REQUEST FOR INFORMATION NOT ADDRESSED IN THIS CCO REMAIN IN FORCE						
MARK	DATE	DESCRIPTIONS	BY	CH'D	CCO#	
②	12/11/09	TOWER UTILITY PANELS	SYC	FW	70	
①	02/19/08	ELECTRICAL MODIFICATIONS	MP	RR	42	
		REVISIONS

**DETAILS
TOWER AND SUSPENSION CABLE
TOWER POWER AND LIGHTING**

E-286

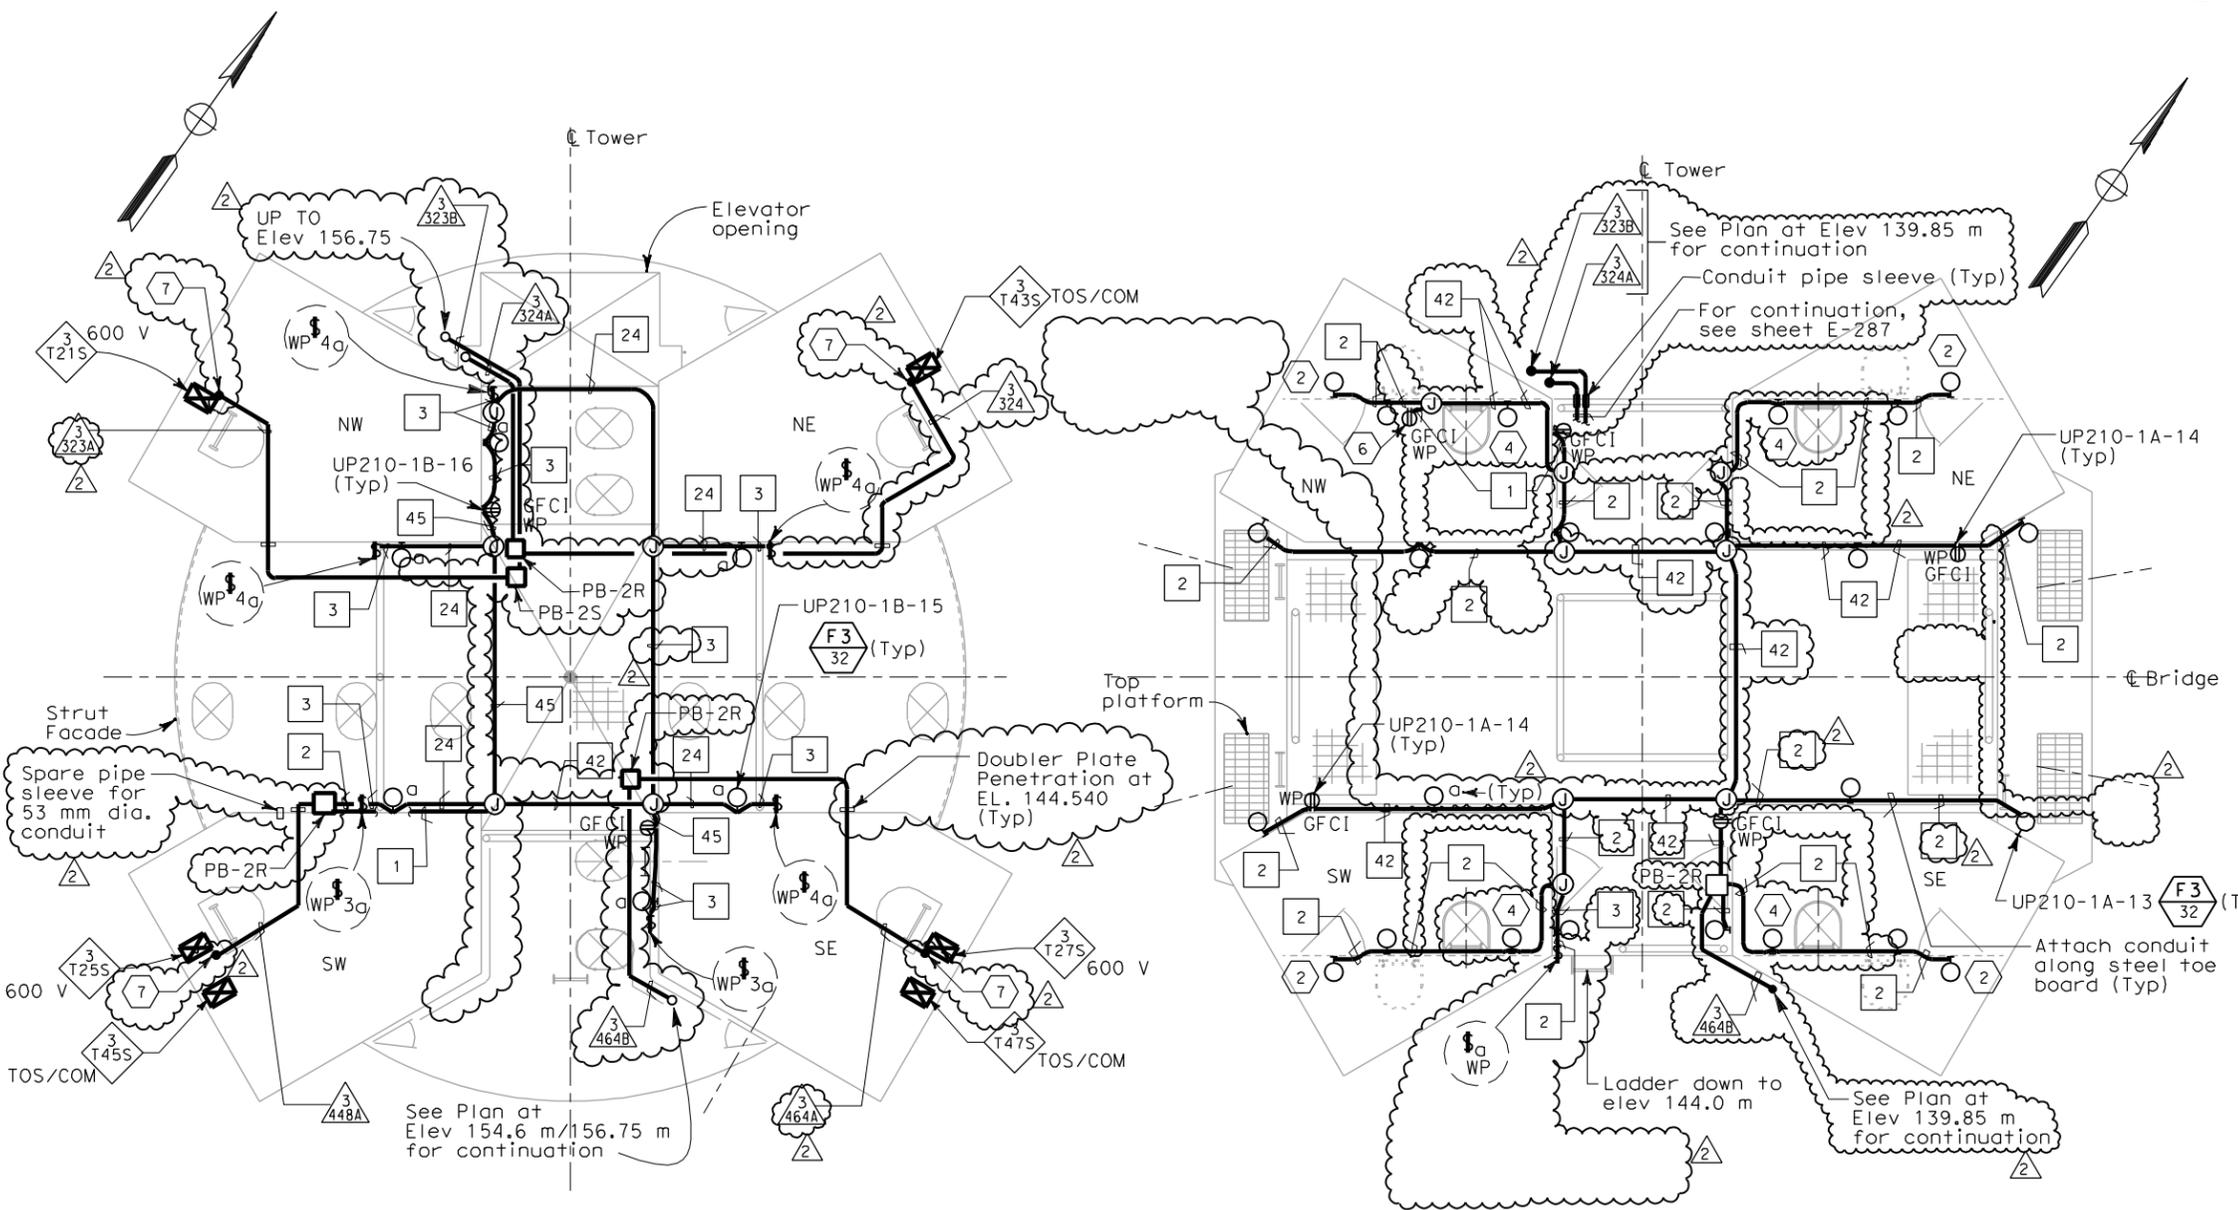
- ① Deleted.
- ② Fixture mounting height elevation shall be 158.5 m.
- ③ Deleted.
- ④ Fixture mounting height elevation shall be 159.25 m.
- ⑤ Conduit from elevation 89.85 up to elevation 156.75.
- ⑥ Receptacle mounting height elevation shall be 158.450 m.
- ⑦ Conduit down to cable tray located below EL. 143.00 diaphragm.
